# 1ST & PIKE

103 PIKE STREET

EARLY DESIGN GUIDANCE 2  
06 FEBRUARY 2018  
DPD #3028428

## 1. PODIUM

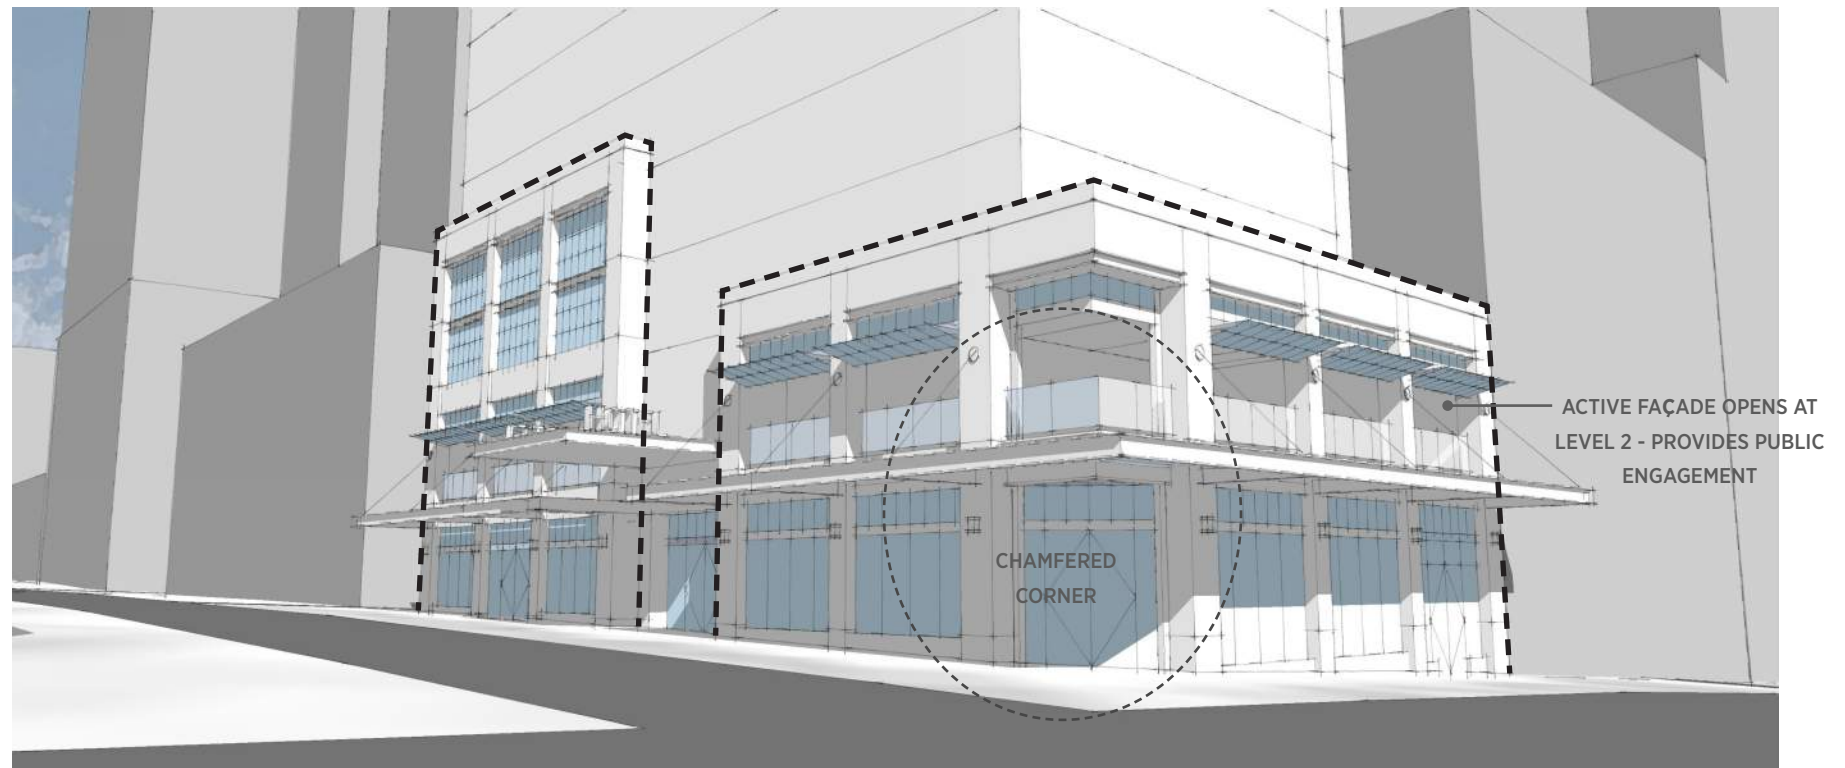
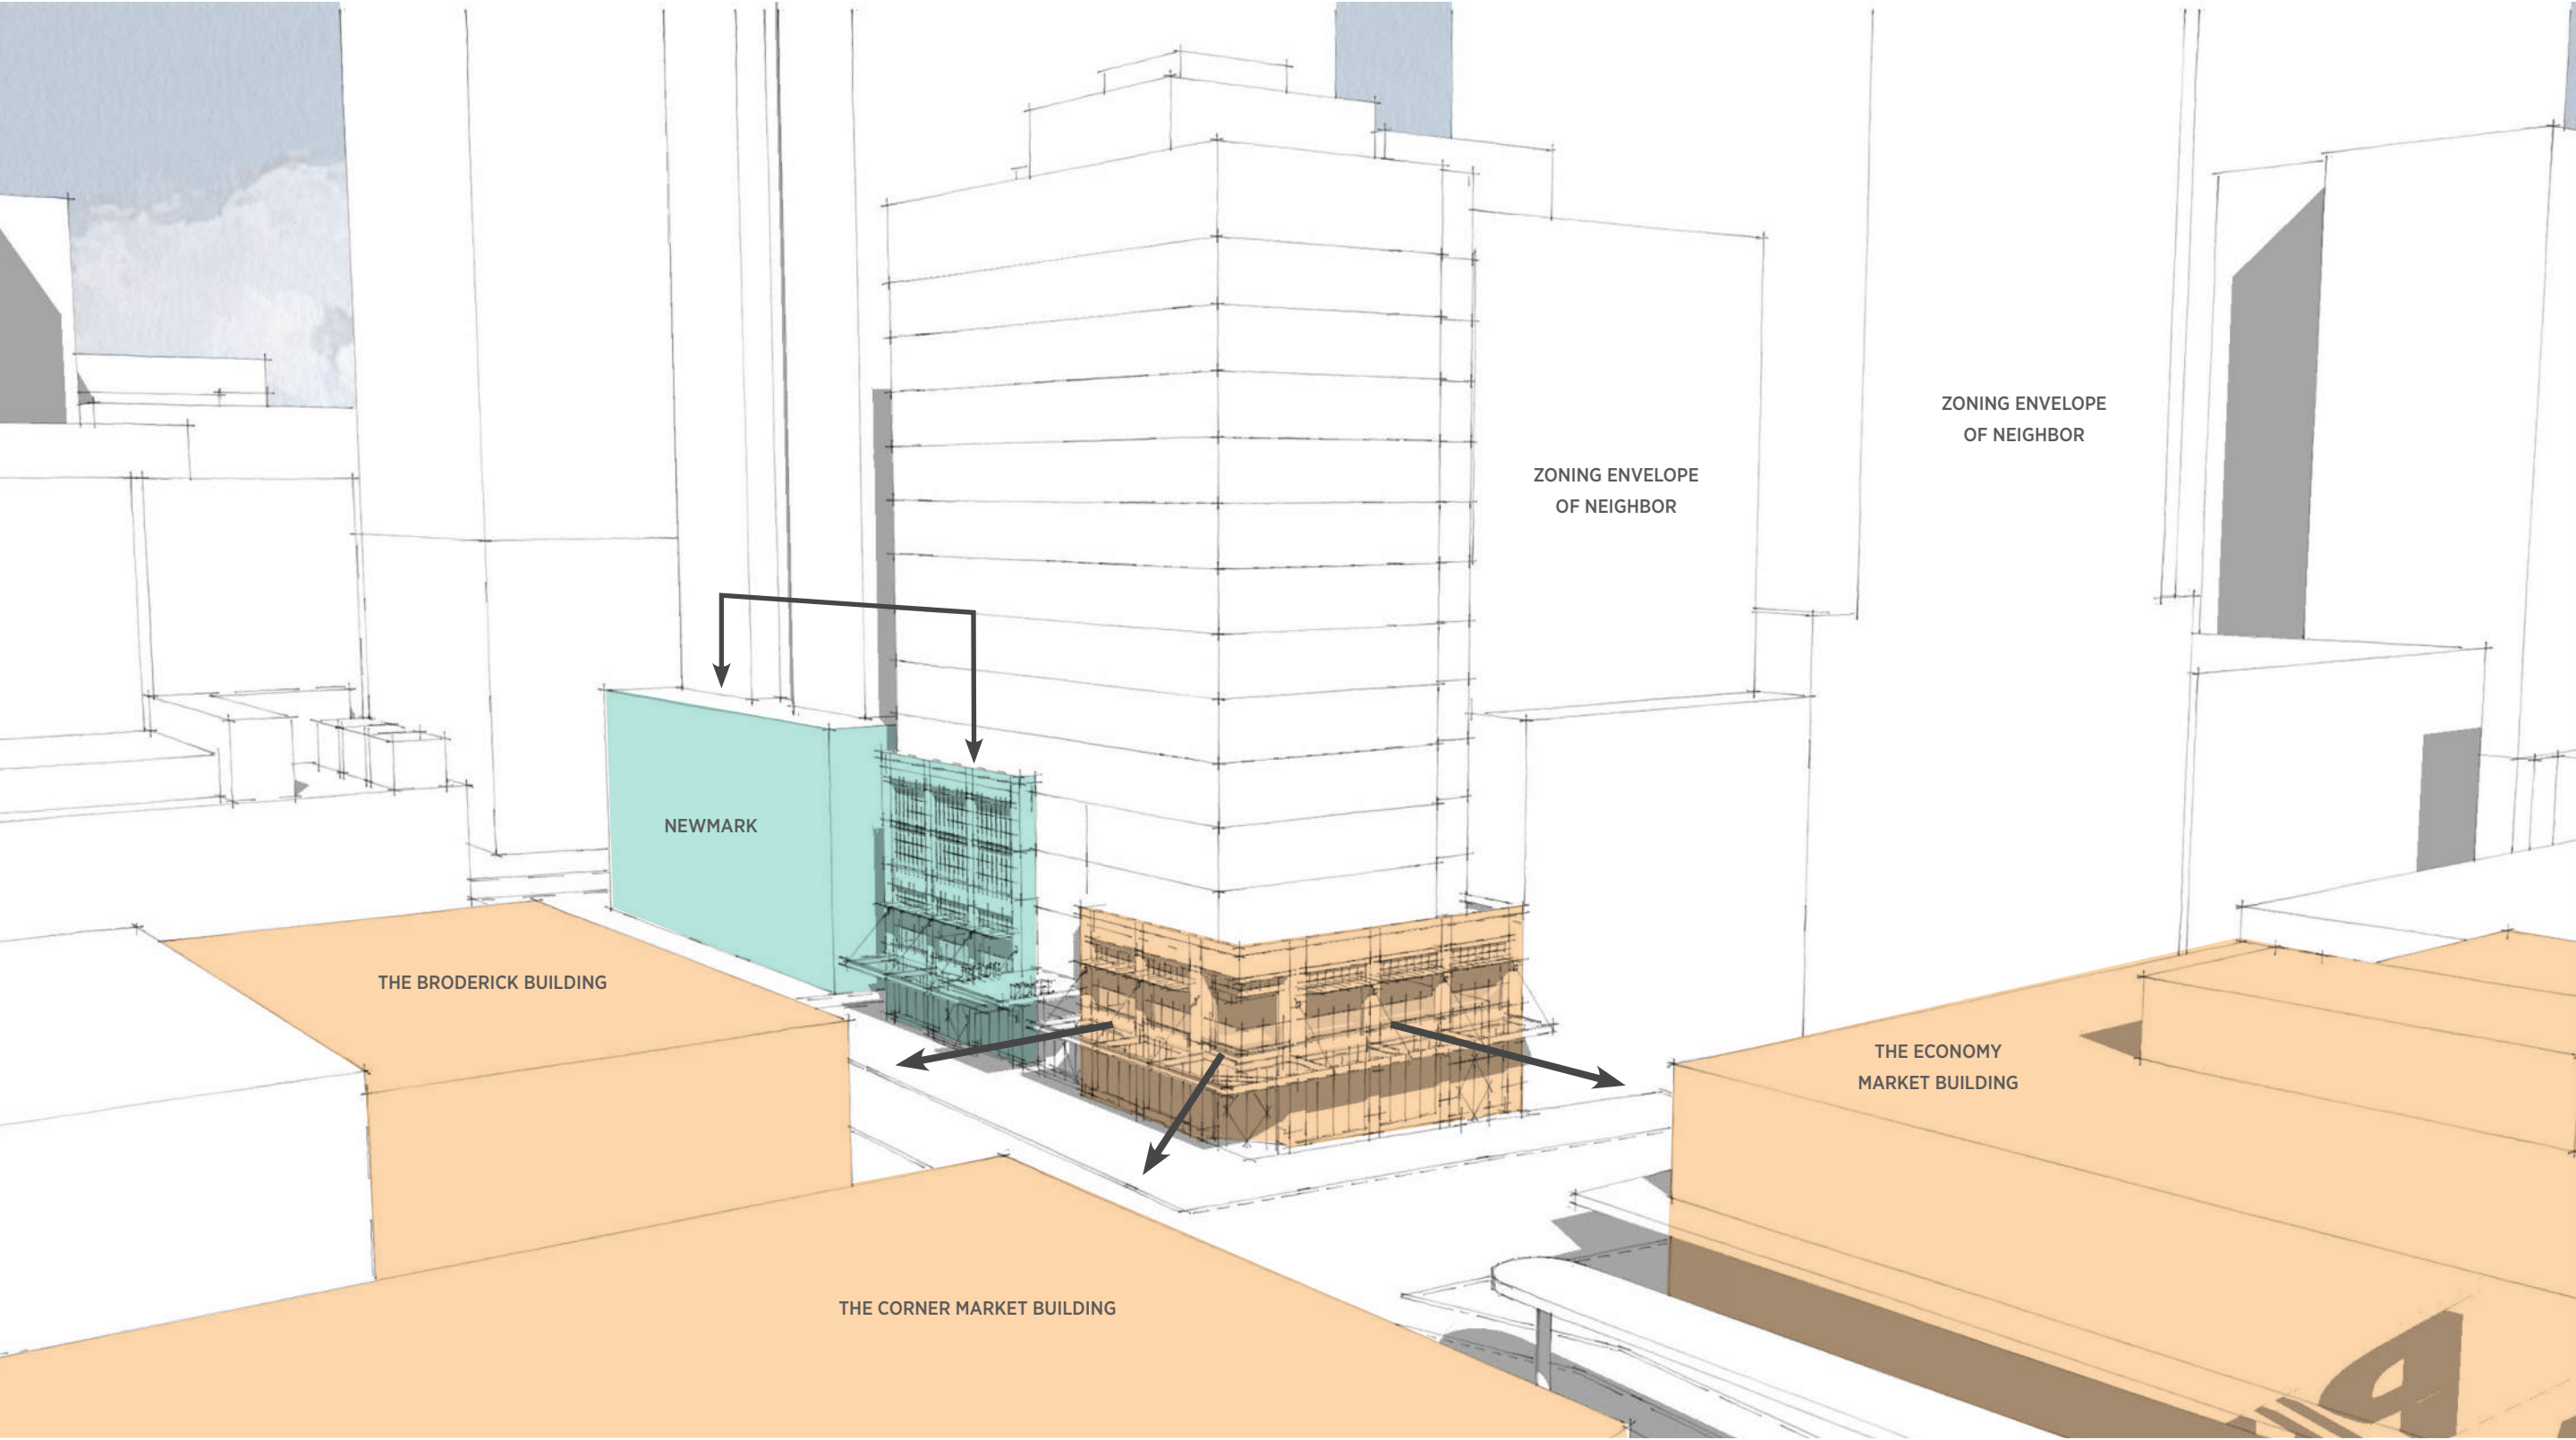
- The Board voiced support for the two-story podium/base of Concept 3 because the podium related strongly to the historical scale and context, in addition to preserving the feel of the existing intersection. Board comments pertaining to the bay rhythm and modulation for this base were also positive.
- Overall the Board supported the location of the ground-level entries for each design concept and stated a strong preference for the chamfered corner entrance, as shown in Concept 1. The Board explained that the design of the corner entry should reinforce the streetscape characteristics (four-way plaza intersection) and the historical architectural attributes in the vicinity

- The revised design maintains the two-story base at the corner of 1st Avenue and Pike Street in order to relate to the existing structures at the intersection. The massing of the base steps up to four stories on the east side of the building, thus responding in height and scale to the podium of the Newmark Condo Building. The main hotel entry is located between the massing elements. The bay rhythm and modulation from the previous EDG massing has been retained.
- The corner has been revised. The corner column has been removed and the corner has been chamfered for ease of pedestrian traffic and retail visibility.

## 1. PODIUM - GLAZING AT ALLEY

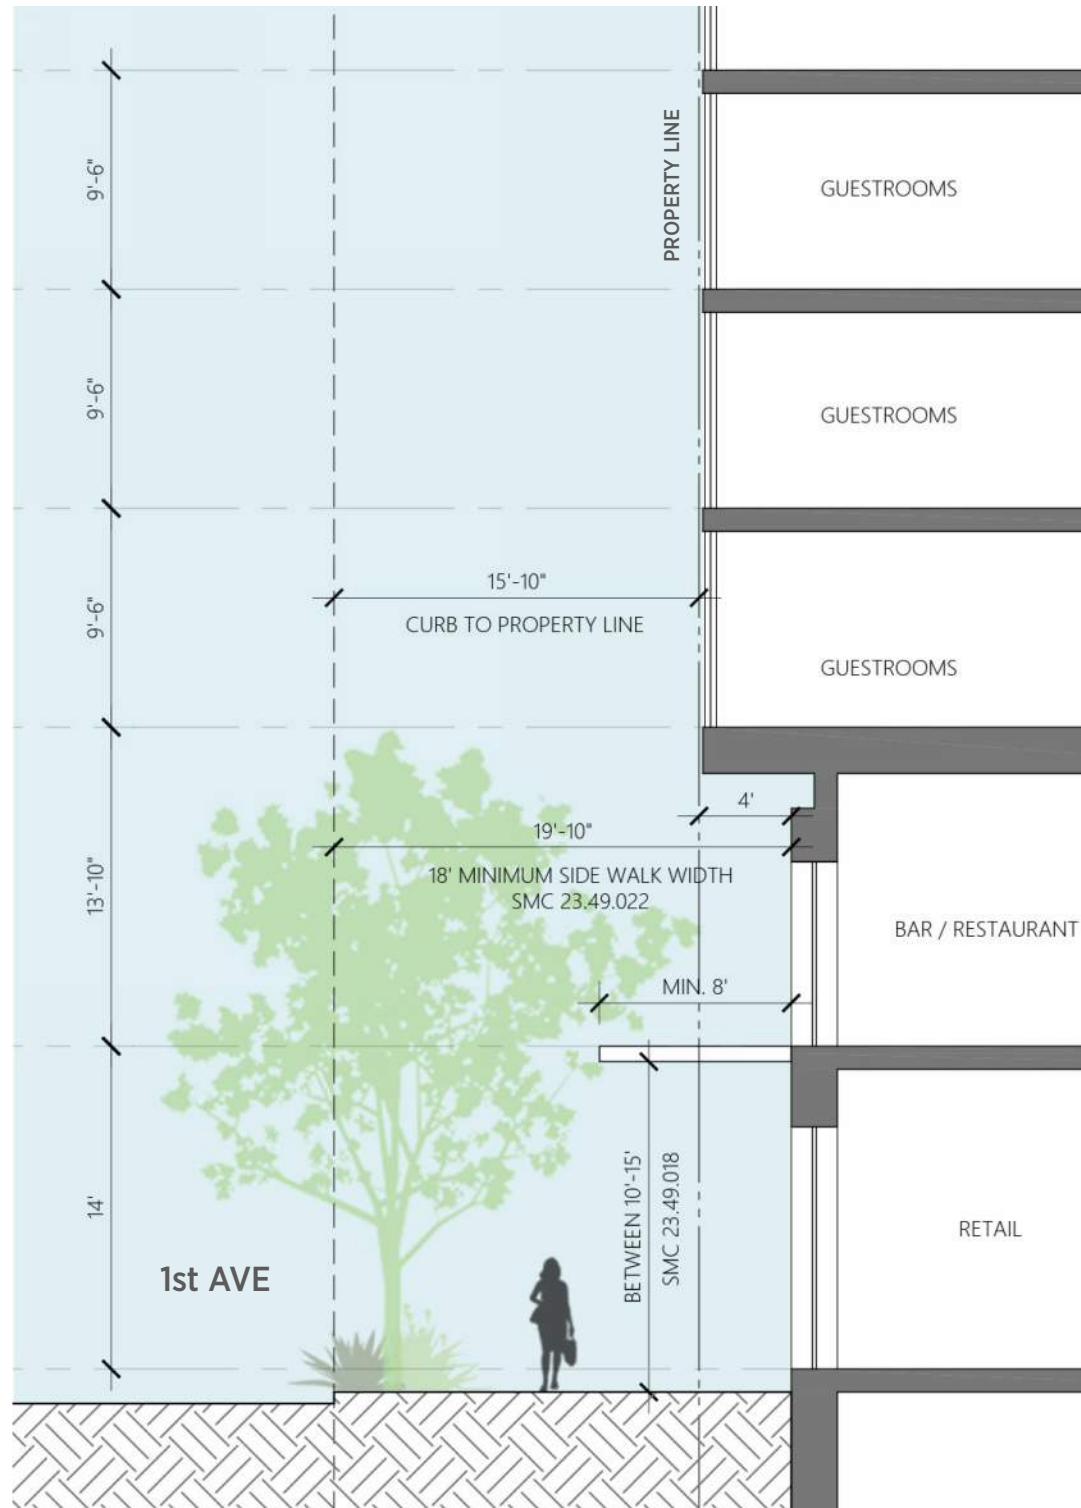
*1.a.ii. The Board requested that the ground-level retail space fenestration extend into the alley to provide some transparency and security at the alley entrance.*

Windows have been added to the northeast corner at the alley. This allows eyes on the street and helps activate the pedestrian experience.
